Re: United States v. CBS Corporation,  
nos. IP-83-9-C and IP 81-448-C (S.D. Ind.)

**CBS CORPORATION'S STATUS REPORT CONCERNING  
THE FEDERAL GOVERNMENT'S PLANS TO CONSTRUCT A  
FINAL WATER TREATMENT SYSTEM AT LEMON LANE LANDFILL  
TO BE OPERATIONAL IN THE YEAR 2000, RATHER THAN BUILD AN  
INTERIM SYSTEM IN 1999, AS IT PREVIOUSLY TOLD THE COURT**

CBS submitted its technical comments on EPA's new system on May 12, 1999, along with a detailed cover letter, figures and tables (copy attached as Exhibit 9). CBS pointed out that what EPA was really designing was a final, not an interim, system, and that the Agency was making important decisions without the complete information that would be available once the excavation work was complete and the hydraulic conduit study was finished. Chief among the decisions made by EPA prematurely was to choose a location for the final treatment plant, determine the size and type of retention system to be used, the amount of pumping capacity, and what types of additional equipment would be needed. The technical comments went into great detail about all of the engineering aspects of EPA's new design.

Figure 1

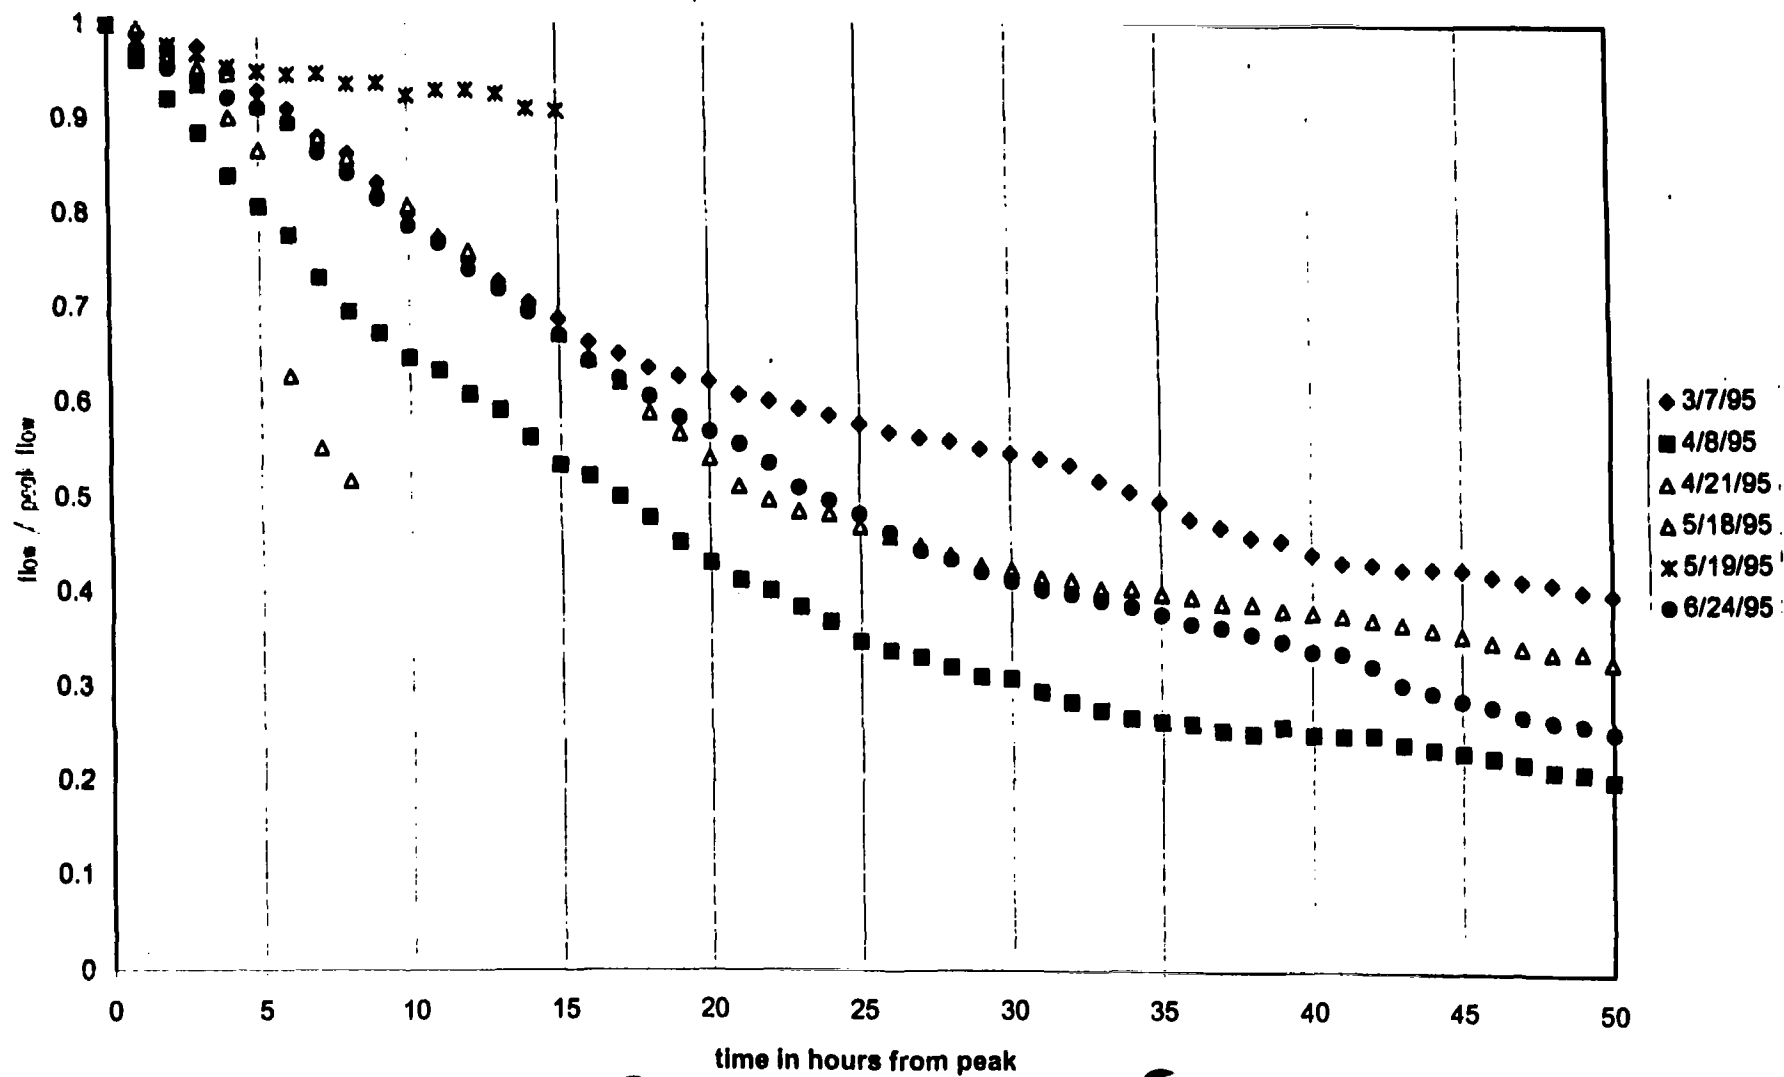
Figures 1 through 4 show the normalized flow hydrographs from the time of peak flow to 50 hours after peak flow for Illinois Central Spring storms with peak flows greater than 1000 gpm (surface runoff excluded) that were recorded between January and June for 1995, 1996, 1997, 1998, and through February of 1999. Table 1 shows the peak flow (surface runoff excluded) for those storms. Inspection of these figures shows that most of the large wet-weather storms at IC Spring have similar-shaped recession hydrographs with 25% to 50% of the peak flow having receded by 50 hours from the time of the peak. The notable exceptions to the general trend are the 1996 storms and the January 1997 storm. Those storms show only 88% to 91% of flow having receded by 50 hours from peak flow. This establishes that using the 1996 water year as a design year is a very conservative assumption. It also shows that using the January 1997 storm is overly conservative, and tends toward over-design.

**Figure 5**  
**PCB Maximum concentration vs IC Spring Peak Storm Flow (Post lining data only)**

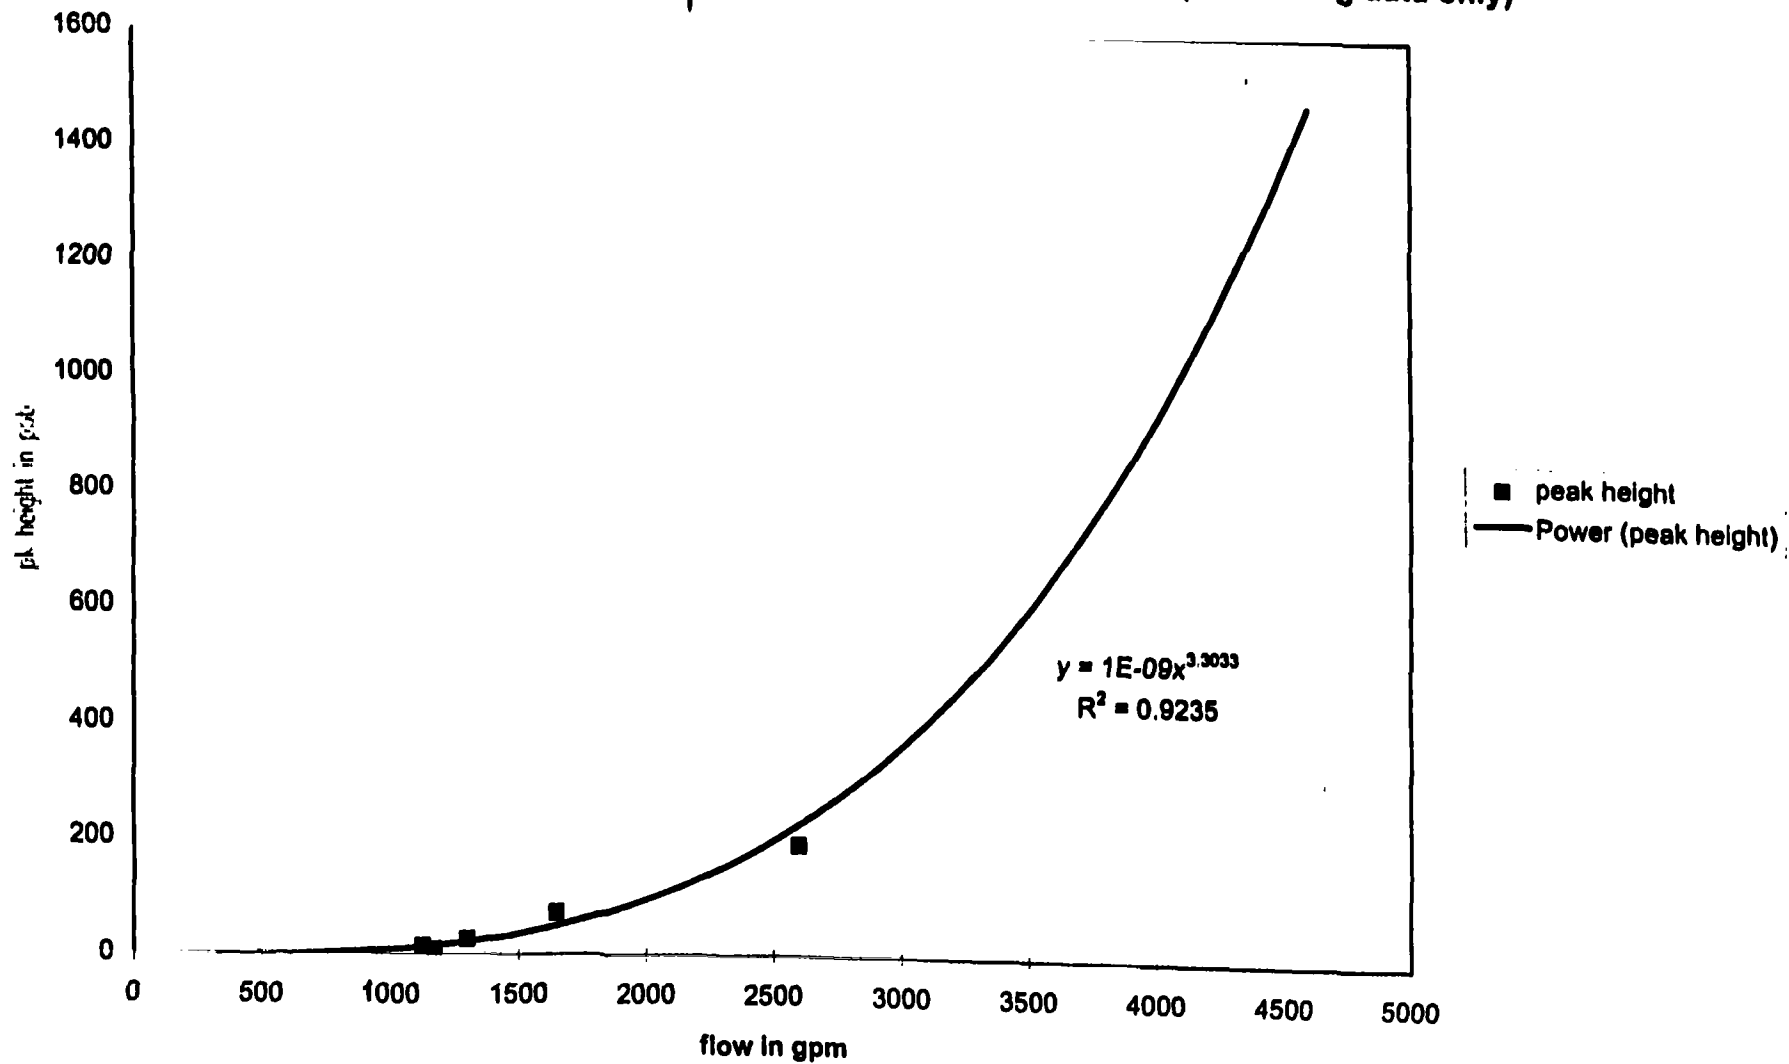
- The April 15, 1998 storm event chemographs for PCB and TSS were unitized by dividing all hourly readings by the maximum reading for the event.
- A correlation between storm peak spring flow and PCB/TSS peak concentrations during storms was developed. The data utilized for these correlations was from 5 storm events where adequate data was available. Figures 5 and 6 show the data and correlations. A power function relationship was chosen as the most reasonable relationship because it gave the best fit correlation coefficient for the data and makes the most sense from a physical phenomenon standpoint. For example, the power of water, and thus its scouring or flushing potential, changes with the flow by a power function.

Figure 8  
 NLF Low Flow Sample Particle Size Distribution

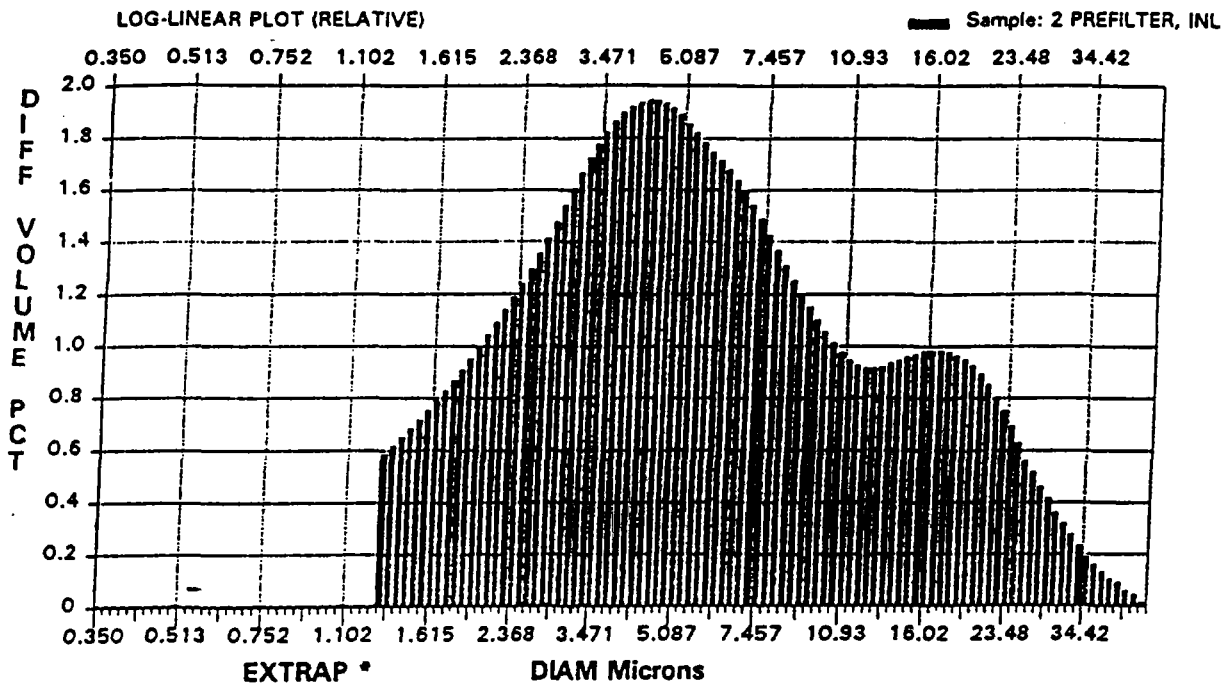
What is the most appropriate design basis storm event is central to sizing solids removal equipment. In the absence of proper particle size information from Earth Tech, CBS can comment on the solids removal equipment based on our experience at Neal's Landfill, some limited data from Neal's Landfill, our experience in sampling Illinois Central Spring, and appropriate literature. In 1994, CBS collected several samples of treatment plant influent at Neal's Landfill and sent the samples to a lab for particle size distribution. Two typical distributions are shown in figures 8 and 9. Note that at low flow, the particle size distribution was centered at about 5 microns and at higher flow, the distribution was centered at 9 microns. While it is not known whether these samples are representative for actual spring conditions at Illinois Central (the samples were taken downstream of the settling basin, actual flow rates are unknown, and the samples did sit for days prior to lab analysis), based on our experience, in taking thousands of samples between both sites, we do expect these springs' TSS loading and distributions to be similar.
